## APPENDIX B

### Summary of DRA Analysis of Late-Filed ALJ Exhibits

#### A. Estimation of hydrotest costs used to calculate disallowances for pipe replacement projects

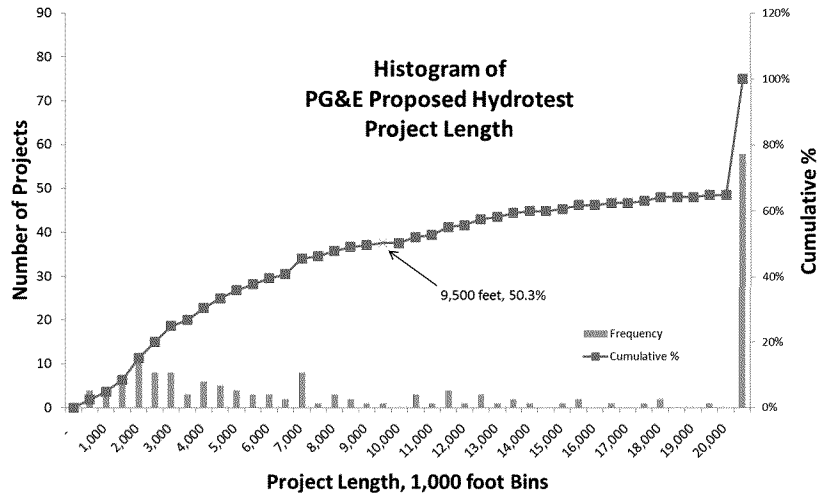
In addition, the record shows that hydrotest costs per foot decrease with increased length of a project, as fixed costs are spread over a larger length of pipe. The following chart shows hydrotest costs per foot for PG&E’s 165 proposed hydrotests projects, as a function of the length of each project:

This chart shows that short test projects, including all those shorter than 10,000 feet, have a cost per foot higher than \$95.8.

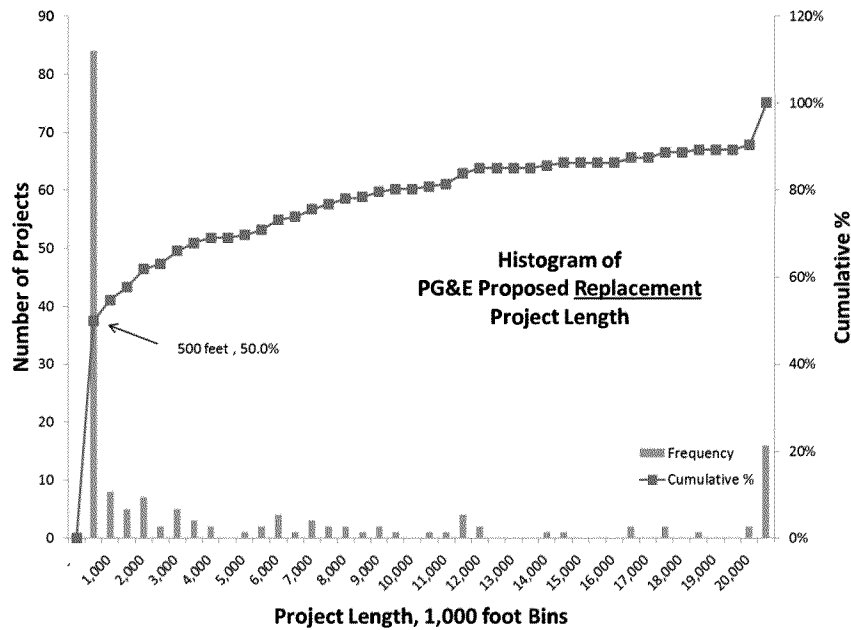
histogram of the 165 hydrotests shows the number of tests (y axis) within each project length bin (x axis):<sup>11</sup>

This chart shows that approximately 2/3 of the *hydrotest* projects are longer than a mile, and 58 projects are longer than 20,000 ft. These long projects, which have a low cost per foot as shown above, drive the average cost per foot used in the PD.

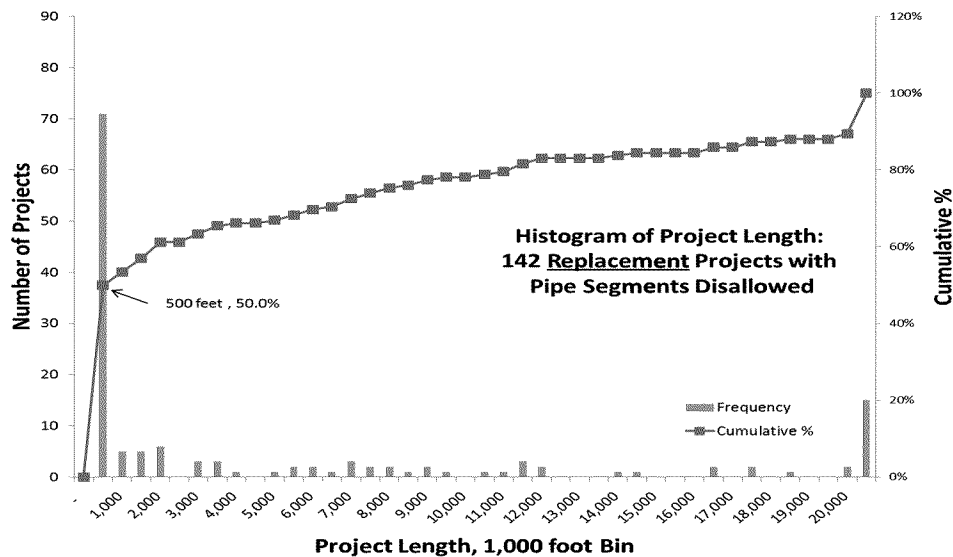
In comparison, the median length of PG&E’s proposed *replacement* projects is 509 feet, over 17 times less than the median length of *hydrotest* projects:<sup>12</sup>

This chart shows that the majority of proposed *replacement* tests (84 of 168) are less than 1,000 feet long.

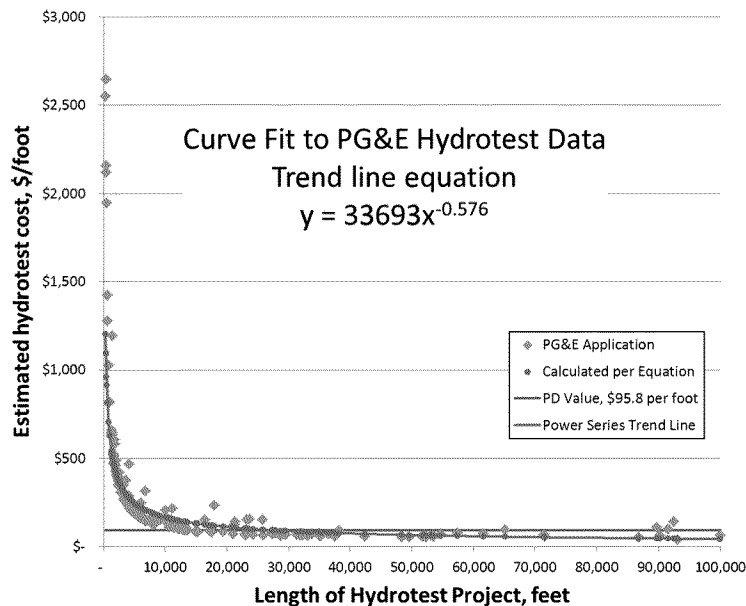
Not all replacement projects have segments that are disallowed, regardless of whether PG&E or DRA’s cost allocation criteria are used. DRA therefore performed a similar analysis on the 142 replacement projects with disallowances using the criteria of Scenario 3 as described in Section II.A.2(a) of DRA’s Comments on the PD.<sup>13</sup> The median value of these projects, 512 feet, and the frequency distribution are similar to the full set of replacement projects:<sup>14</sup>

This data shows that PG&E pipe *replacement* projects are much shorter than *hydrotest* projects, and that the single estimated hydrotest cost of \$95.8 per foot is inappropriately low for use for replacement projects, the majority of which have short pipe lengths.
